Subject: Response to Request for Additional Information (RAI) Regarding Proposed  
CREATS Modification and Change in Dose Calculation Methodology to Alternate  
Source Term  
R.E. Ginna Nuclear Power Plant  
Docket No. 50-244

Response to Request for Additional Information (RAI)  
Ginna Control Room Emergency Air Treatment System (CREATS)

CREATS  
 ELECTRICAL  
 BLOCK DIAGRAM

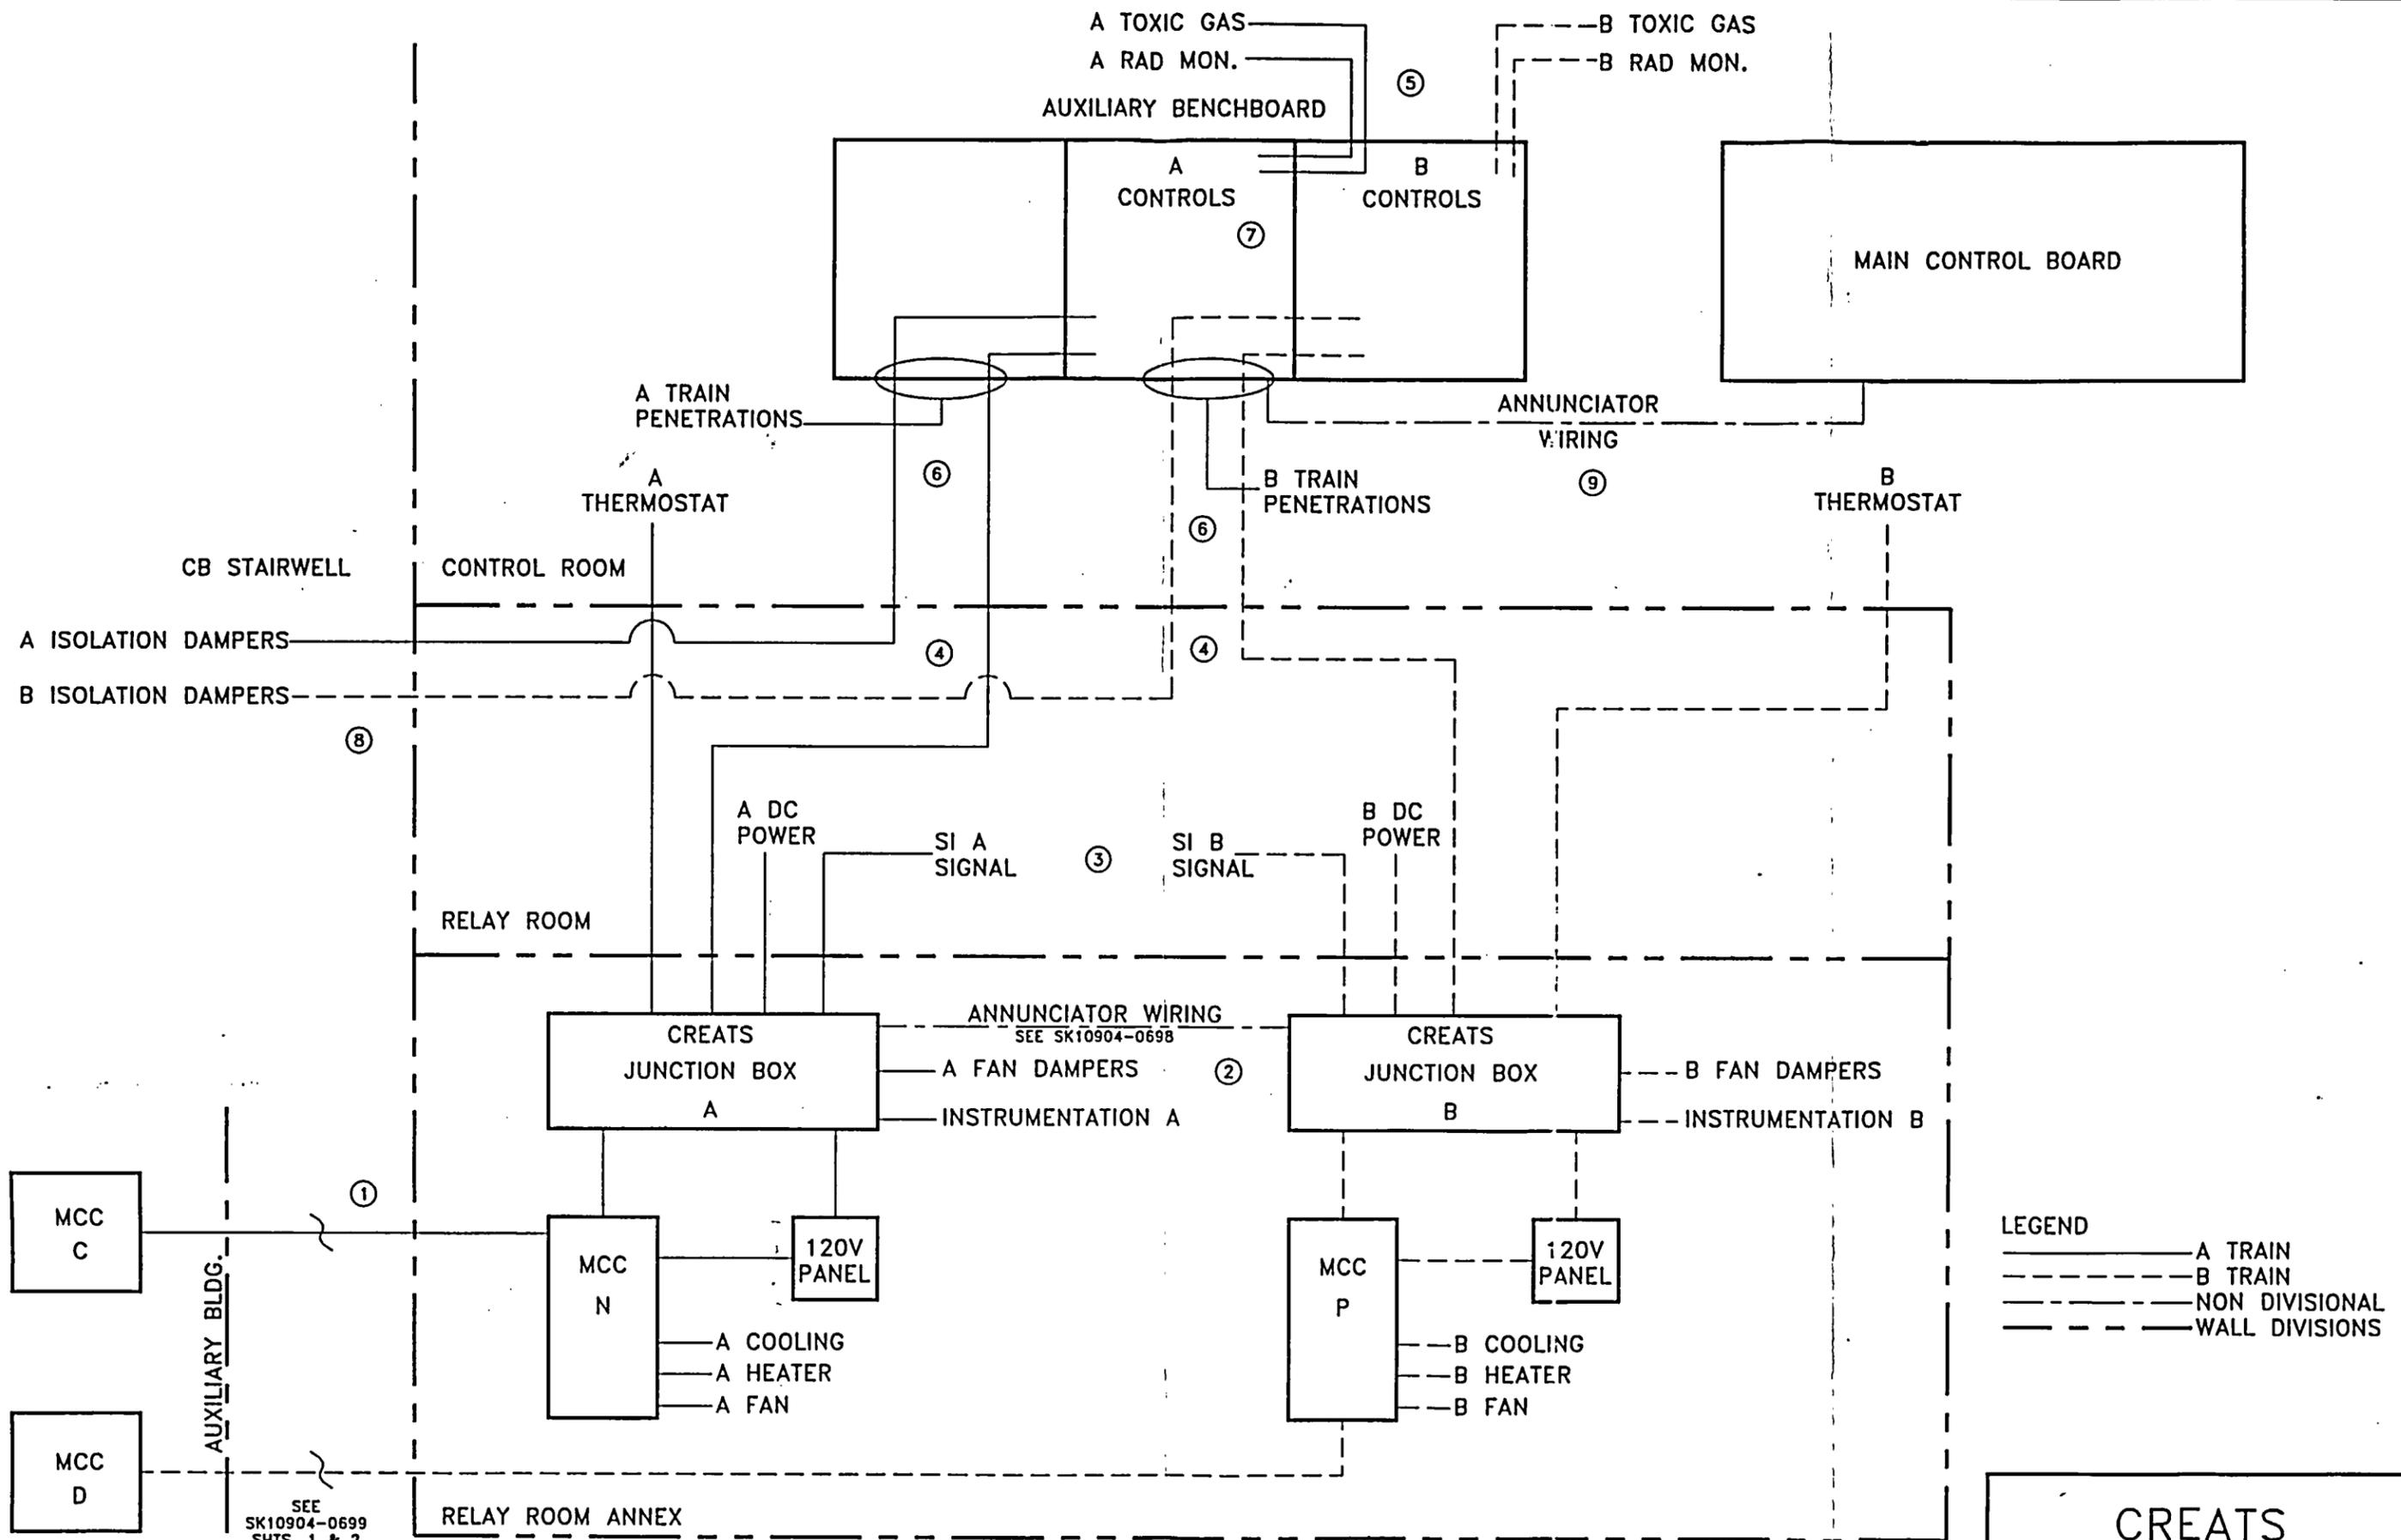
26. *Attachment 7 Section 7 lists various interfacing systems. Please describe the nature of the signal and electrical interfaces, and specify the nature of the signals. Show that adequate separation and isolation will be maintained. A block diagram sketch showing signal and power connections, separation, and isolation would be helpful.*

Response: The attached block diagram (Attachment 2) of the connection between electrical panels and devices has been created to illustrate power connections and separations. The design of the safety system precludes the use of components that are common to redundant portions of the safety system, such as common switches or sensing lines, which could compromise the independence of redundant portions of the safety system. Device and train separations is evident by inspection of this drawing in most cases. The following explanation describes how this is maintained where not evident on the drawing. The numbers correspond to the note number on the attachment.

1. Cables from MCC C and MCC D to new MCC N and MCC P are the main 480 volt power supplies for the new equipment. They are routed in tray and conduit. That routing and the evaluation demonstrating separation of these circuits was previously submitted in Reference 5. None of the wiring being added for the controls portion will introduce any wiring that would impact the separations already demonstrated for those cables.

2. All of the cables installed in the relay room annex outside of panels will be in conduit, with each conduit only carrying cables of a single train. The only non-divisional conduit will be the conduit from the A junction box to the B junction box, which will carry the control circuits that parallel relay contacts for the annunciator signals. Those cables are not redundant, as they are only for non-safety indication. Isolation from train specific wiring in the cabinets will be provided by the relays

to which they are connected. These circuits can be seen in a drawing previously submitted in Reference 5.

3. The A and B SI signal cables, and A and B train DC control power cables, will come from the Relay Room into the annex. Those cables will be routed in tray while in the relay room, then transition to train specific conduits before penetrating into the Annex. While in tray, the cables will be routed independently, maintaining adequate separation until transitioned into conduit. Sections of trays being utilized will not contain cables of the other train that are required to perform a redundant safety function.

4. Control cables that are being routed from the relay room annex to the auxiliary benchboard (ABB) will start in conduits in the annex, then transition into trays in the relay room. While being routed through the relay room tray system, separation between trains will be maintained throughout the routing to the benchboard. Sections of trays being utilized will not contain cables of the other train that are required to perform a redundant safety function.

5. Auxiliary Benchboard (ABB): The Controls and internal wiring for each train have been separated by the sections of the ABB. Previously submitted drawings show the controls on top of each section. The ABB center section will house A train components, the ABB right section will house B train and non-divisional (normal HVAC) components. The cabinet panels will provide the separation between the devices. Items 6 and 7 below address cables that route through the ABB. Per IEEE 384, inside of the cabinets, wiring of redundant trains must maintain minimum separation distances or have a suitable barrier between trains. That minimum separation will be maintained for all train specific wiring associated with this modification, or suitable barrier will be installed between circuits minimum separation distances cannot be maintained. On the ABB control panel drawing, indicating lights for both trains of isolation dampers are located next to each other for operator human factors considerations, so the operator can quickly assess the status of dampers in each flow path quickly and accurately. To maintain separation between the two electrical trains at the terminals on the rear of the light sockets, a steel plate will be connected to the underside of the ABB top panel between the two rows of lights. That plate will be long and deep enough to provide adequate separation between these two sets of circuits where they terminate on the rear of the light sockets. Radiation monitoring toxic gas cables entering the rear of the ABB will be rerouted to support this configuration. A train cables will enter from the right rear of the ABB and route through a dedicated hole to

the center section. B train cables will stay in the right section. Adequate separation distance will be maintained between the A and B train cables inside of the cabinets. Toxic gas cables terminate on a fuse block. These are the fuses shown on previously submitted drawing SK10905-0546 sheets 1 and 2 (Reference 5) that provide isolation between the safety related CREATS equipment and the safety significant toxic gas detectors and power supplies.

It should be noted that there are a set of wires in the ABB that go between an A train device (relay R81A) and a B train device (relay R81B). Independence of those circuits is discussed in the response to RAI question 29.

6. Entry into the Auxiliary Benchboard (ABB) will be through penetrations in the relay room ceiling/control room floor, directly into the ABB. To maintain separation, and to utilize existing penetrations, installation will be as follows:

A train cables will enter the ABB in the right hand section, route to the rear of that section before going between sections through a panel penetration into the center section, near the rear of the ABB. After entering the ABB center at the rear, the cables will route up to terminal blocks mounted on the rear face of the ABB center section.

B train cables will enter the ABB center section in penetrations at the front of that section. These penetrations are more than 6" from any A train cables that are entering and routed at the rear of this center section. After entering the center section, the B train cables will route to the ABB right section through a panel penetration, again maintaining adequate separation distances from B train cables.

7. Wiring internal to the ABB that ties devices that share common circuits (such as the wires that have contacts from both R81A and R81B in series, see previously submitted drawing SK10905-0546, Reference 5), will be routed through a separate hole in the ABB separator panel dedicated to these wires. The contacts of the BF relays that are in these circuits provide the separation of the trains so that a failure of a device in one train cannot propagate to the other train through the common device.

8. Circuits from the junction boxes to respective thermostats, and circuits from ABB to stairwell isolation dampers, will utilize a combination of conduit and trays. Separation will be maintained throughout the routing of these circuits. Sections of trays being

utilized will not contain cables of the other train that are required to perform a redundant safety function.

9. Two circuits for the annunciator window circuits route from the ABB to the Main Control Board. These circuits are not redundant circuits, but each go to a different annunciator window. These circuits can be seen in drawing SK-10904-0698, previously submitted in Reference 5. These circuits will route out of the ABB through a penetration, and go through the Relay Room into the MCB. These non-divisional cables will be routed so that they maintain separations between the two trains by not utilizing a routing where cables from both trains for redundant functions are installed.
